# 1992 Corvette ZR-1: Service Bulletin: Lack of Wide Open Throttle Engine Underpower

**Subject:** LACK OF WOT-LOW ENGINE POWER REVISED CABLE ADJUSTMENT PROC.

**Model and Year:** 1992 CORVETTE ZR-1 WITH 5.7L ENGINE AND MANUAL TRANSMISSION

**Bulletin Number:** 92-214A-7B - (07/01/1992)

THROTTLE BODY AND ACCELERATOR PEDAL CABLE ADJUSTER

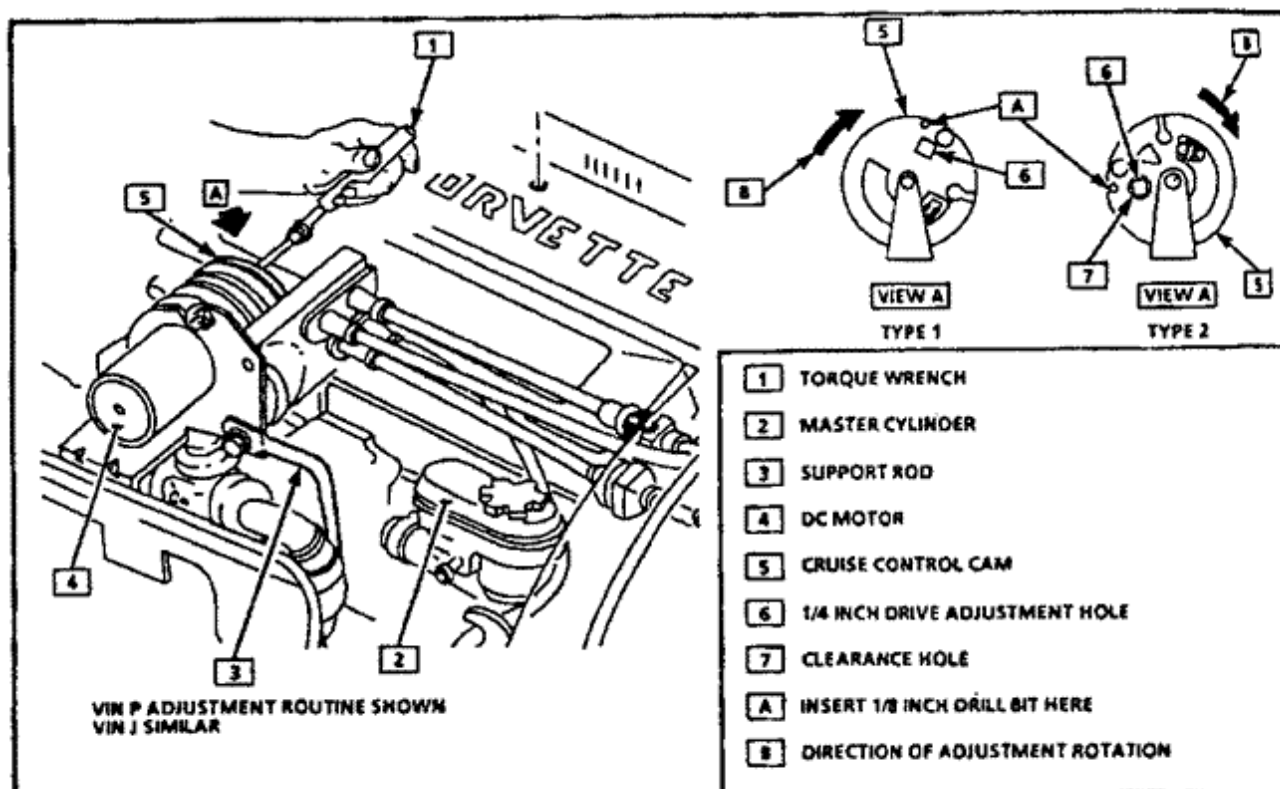
BEFORE MAKING ANY ADJUSTMENT, use a Tech 1 with an 88-92 Brake System Cartridge, check throttle angle percentage by depressing the accelerator pedal. When the pedal is fully depressed, throttle opening should be 100 percent. When the accelerator pedal is released, throttle opening should return to 0 percent. If proper results are not obtained, follow the revised ABS/ASR system adjustment procedures below to improve the above

1. Remove adjuster cam assembly splash cover, foam shield, and cable cam cover.
2. Disconnect cruise control cable from the cruise control servo.
3. Depress reset button on the throttle control cable and fully extend cable sheaths (see figure).
4. Insert a 1/8 inch drill bit into adjuster assembly alignment hole (see figure, item A).

5. Insert a torque wrench with a 1/4 inch drive extension into square hole on the cruise control cam (type 1) or through the cruise control cam into the accelerator cam (type 2) (see figure, item 6).
6. Turn the torque wrench clockwise until obtaining a torque of 4 N.m (35 lbs. in.). During adjustment, several clicks of the adjuster should be heard. If not, repeat step 3.
7. Remove the torque wrench AND drill bit.

10. Using a Tech 1 with an 88-92 Brake System Cartridge, check throttle angle percentage by depressing the accelerator pedal. When the pedal is fully depressed, throttle opening should be 100 percent. When the accelerator pedal is released, throttle opening should return to 0 percent. If proper results are not obtained, check cables for kinks or damage, and repeat adjustment procedures.
